Access Compliance Report

Public Rights-of-Way

(Pedestrian Signals)

Intersection ID: N/A	Main Street:	Cross Street: N/A	Location: N/A
ADA ID: E2295451EA34	Signal Type: One Push Button-Non APS	Overall Compliance: No	Severity Score: BTN 1: N/A BTN 2: N/A No BTN: N/A
Codes/Mitigation Info/Possible Solution		Field Measurements/Component Compliance

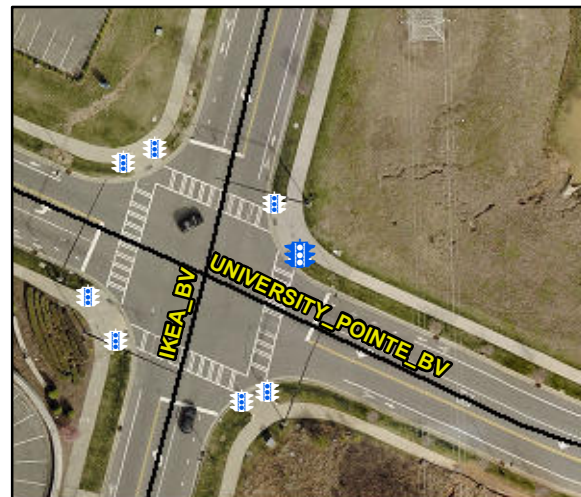
Possible Solutions: Replace Signal Push Button With APS Button on New Post. Remove & Relocate Sign.

PROW/ADA: TMUTCD 4e.08, R404.2, R404.3, R406.2, R404.7.2
